Response to submissions – Addendum - Email Requests and Responses

# West Angelas Revised Proposal

Assessment Number: 2290

RTIO-1095514

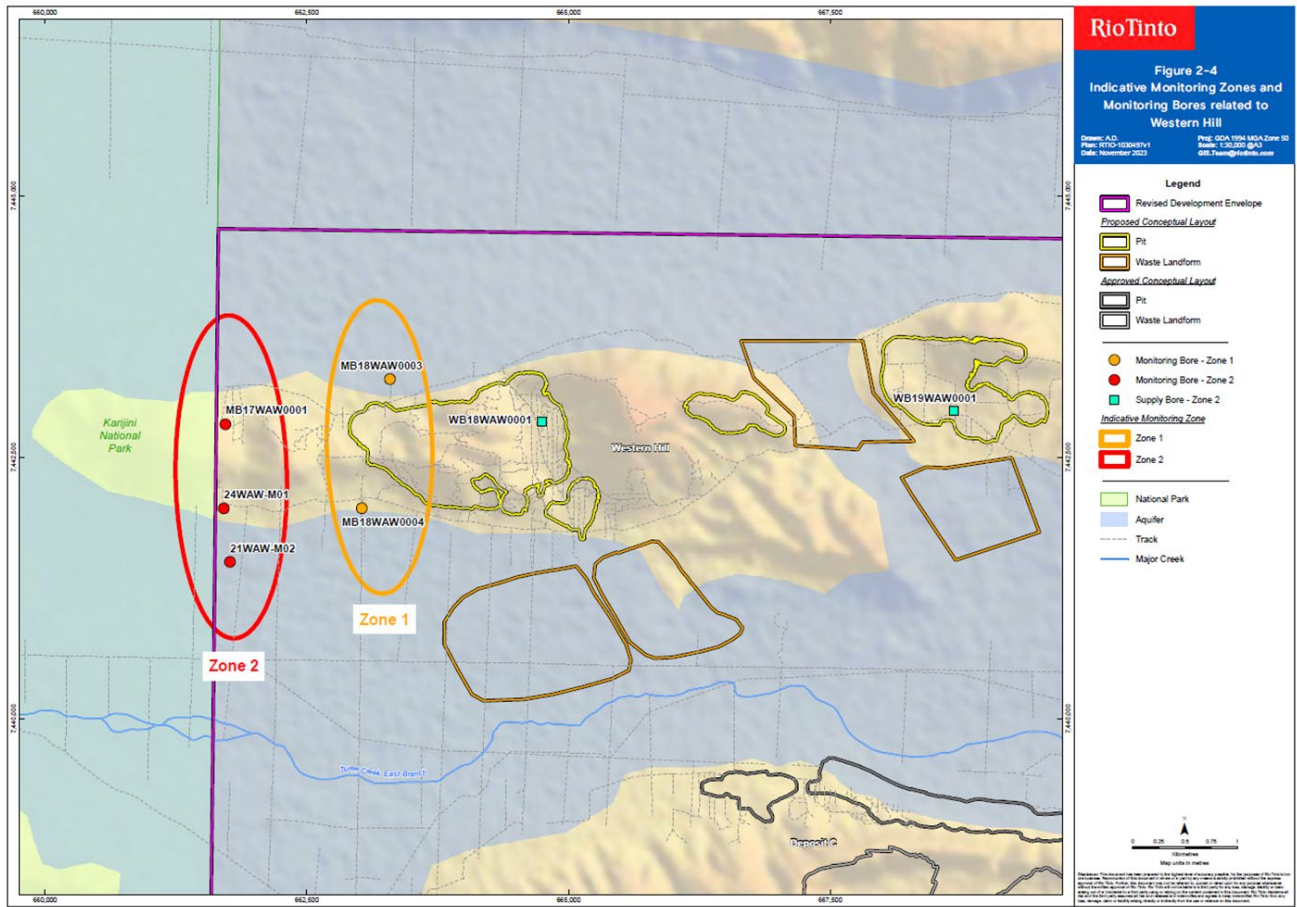
**Q: Please confirm whether the tables below are the maximum drawdown limits at Western Hill and Deposit H. Please provide a shapefile and excel spreadsheet with coords of these monitoring bores. If these aren't the relevant bores, please provide all the requested information for the correct monitoring bores.**

- The Proponent has already proposed an environmental outcome: 'no drawdown at the boundary or within Karijini National Park, and no change to water quality at the boundary of or within Karijini National Park'.
- The outcome will be managed via implementation of the West Angelas Groundwater Environmental Management Plan (Appendix A.9 of the published ERD). The Groundwater EMP includes robust monitoring and management to provide assurance and demonstrate compliance with this outcome. No maximum drawdown limits are proposed.
- Zone 1 (early warning and trigger) and zone 2 (boundary bores) locations have associated early warning indicators, trigger levels and thresholds and are shown on Figure 2-4 of the GEMP (and below).

- Coordinates for monitoring bores are provided in the table below. Note that excerpts provided in your request email are not correct bores as they relate to test pumping.
- These activities will be subject to the relevant provisions under Part V of the EP Act and the Rights in Water and Irrigation Act 1914 (RiWI Act)

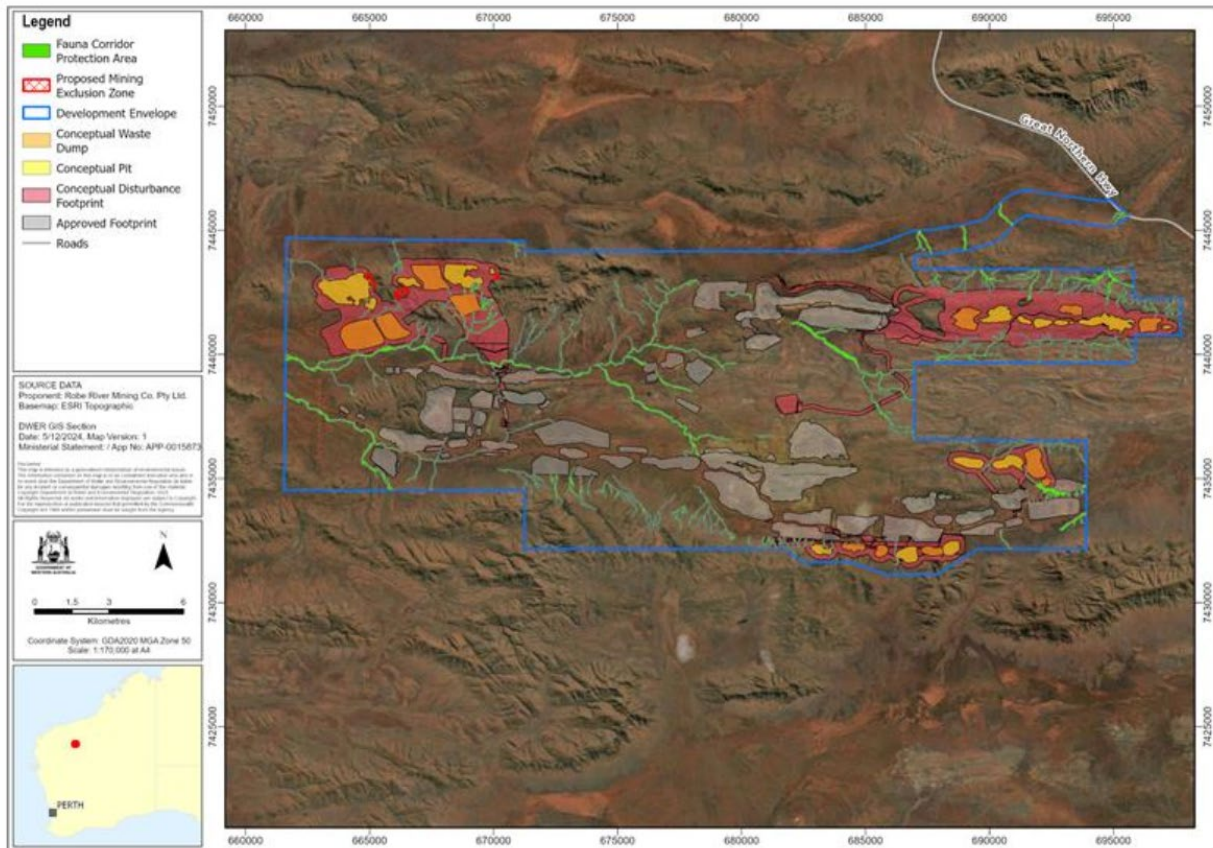
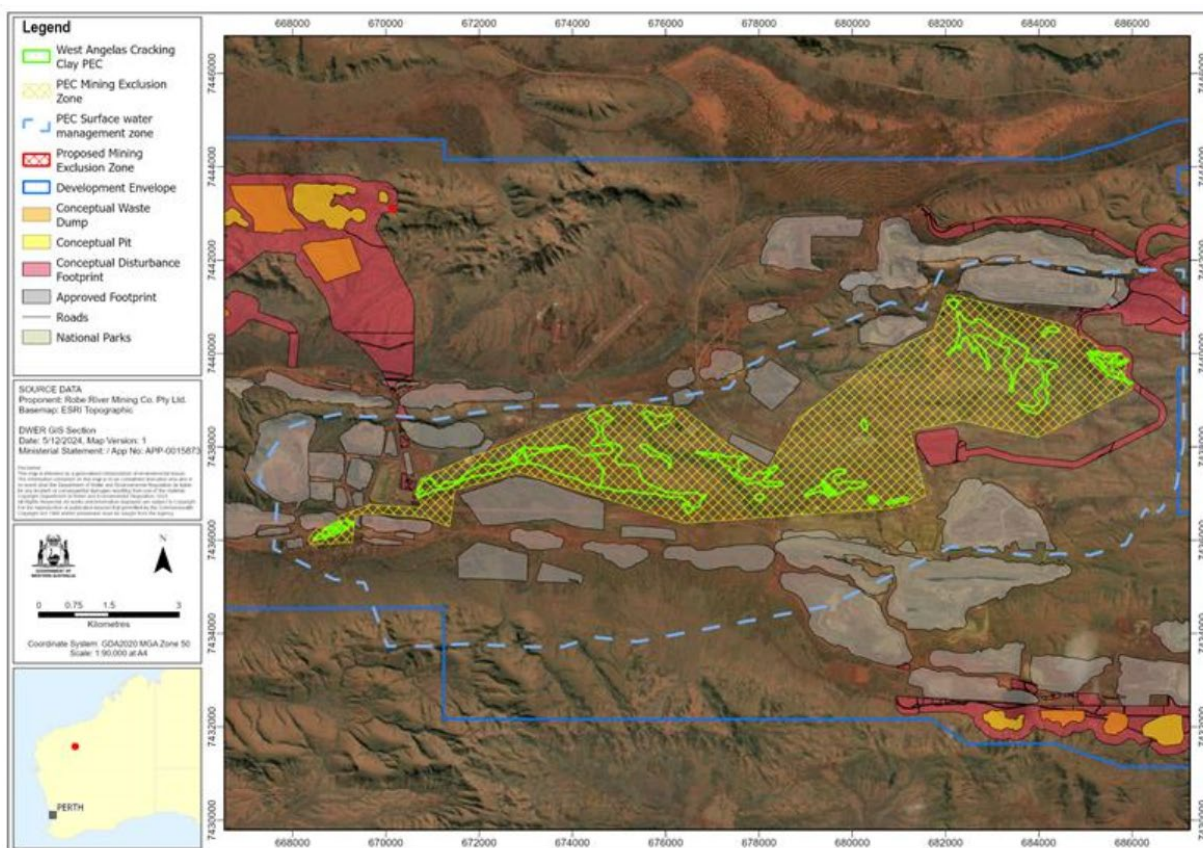
**Q:** In addressing gaps for items FV1 and TF1 in the Response to Submission Addendum provided on 2 December, we (EPA) are proposing a PEC MEZ for the West Angelas Cracking Clay PEC and a Surface Water Management Zone (in attached map) to ensure surface water flow and quality are maintained for the viability of the PEC.

We (EPA) are also proposing a Fauna Protection Corridor Area (in attached map) to maintain ecological connectivity for significant fauna species within the development envelope.

Please provide any further response to the proposed PEC MEZ and management zone and the Fauna Protection Corridor Areas by close of business today.

**A:** Please see comments on the EPA proposed PEC MEZ and surface water protection zone:

- The Proponent proposed a MEZ and surface water protection area MRZ for the large intact expression of the Cracking Clay PEC 2015-5.
- The Proponent cannot accept such a large exclusion area as proposed by the EPA over an existing approved mining area. The EPA proposed MEZ and surface water protection zone impacts the ability of the Proponent to implement the approved existing operation and the Proposal due to its large extent and coverage of non PEC vegetation types that are currently authorised to clear under MS 1113.

- Changes have already been made within the proposed PEC surface water management zone as a result of the approved operations from rail, road and other infrastructure such that the proposed EPA surface water management zone would not add any additional protection to the PEC, i.e. PECs are not connected and are naturally discrete expressions of the PEC.

- The EPA proposed PEC MEZ excludes multiple vegetation types, not just the Cracking Clay PEC and is much larger than is required to protect the PEC from fragmentation and edge effects.

- The EPA proposed MEZ is located over an existing approved development envelope of an operational mine and infrastructure may be required to be located within this area.

- The PEC surface water management zone extends outside the Development Envelope and the Proponent cannot manage these areas.

- As noted in the ERD, the Proponent has authority under the existing approval (MS 1113) for clearing of up to 20 ha and requires up to 2 ha of clearing within the PEC for infrastructure related to the Proposal.

EPA proposed Fauna Protection Corridor Areas:

- The Proponent does not consider the proposed fauna protection corridor as provided by the EPA to be required and the Proponent considers that this matter can be managed adequately through similar conditioning to BSP in relation to fauna dispersal at Western Hill and Deposit H.
- The proposed EPA fauna protection corridor areas would impact the ability of the Proponent to implement the approved existing operation as infrastructure may be required to be located within this area.
- The Proponent will design the Proposal to avoid and minimise fragmentation including ensuring natural dispersal corridors within drainage line and creeks are retained at key locations through the appropriate placement and design of linear infrastructure to achieve the outcome of not impeding water or fauna dispersal.

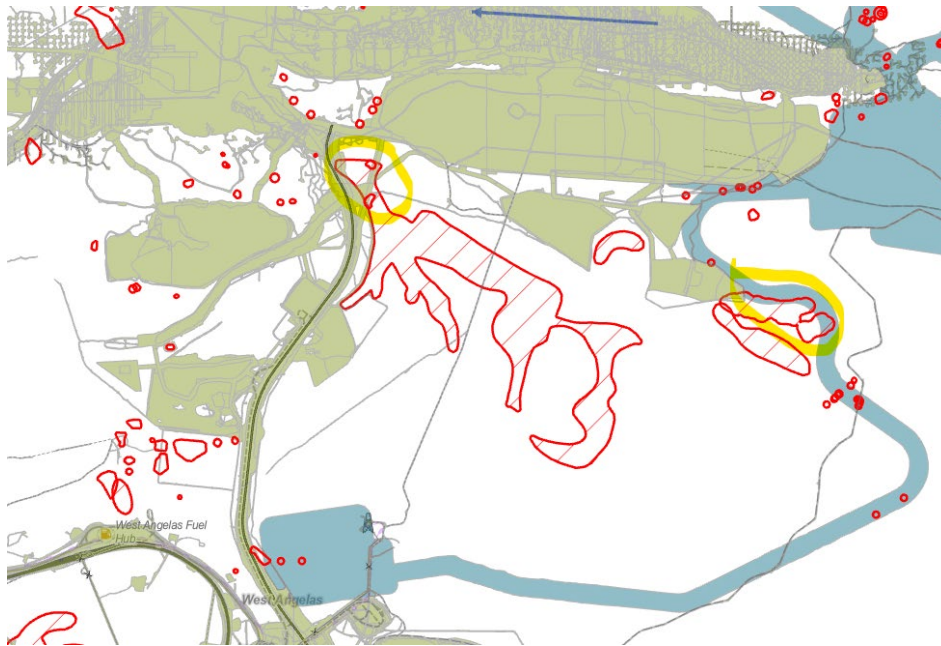
**Q: Provide locations of where the 20 ha of the PEC has been cleared under MS 1113 and the 2 ha is proposed to be cleared under the significant amendment.**

**Q: Provide the areas proposed to be cleared under MS 1113 within the EPA proposed MEZ.**

**A:** The PEC is managed by the use of a clearing limit of 20ha and can be undertaken in any location other than the defined protection area under MS 1113. To date 18.5 ha has been cleared of the 20ha limit. The majority of clearing of the PEC has been undertaken in the small area to the south west of the large 2015-15 expression. Limited clearing has been carried out in other areas of the PEC. The remaining clearing for the Approved Proposal under the current MS 1113 limit cannot be specified, the approved proposal has a remaining mine life that spans several years and the exact location of infrastructure for the Approved Proposal is not known currently. The Proponent commits to avoiding and minimising impacts to the PEC as far as practicable for the Approved Proposal within the 20 ha approved limit.

**A:** The additional 2ha of clearing of the PEC for the Proposal is proposed to be managed by a limit as it could be either undertaken within the northern area of the PEC expression to the south of the existing Deposit B, which has been cleared by current operational activities to aim to minimise impacts through use of existing cleared areas (with widening of existing roads required) or within the eastern most expression of the PEC in the Development envelope, after completion of detailed engineering for the haul road. The Proponent notes that the use of a limit and internal exclusion zones through the Proponent's Ground disturbance system has been effective at limiting clearing and that the remaining PEC is still functioning as a PEC.
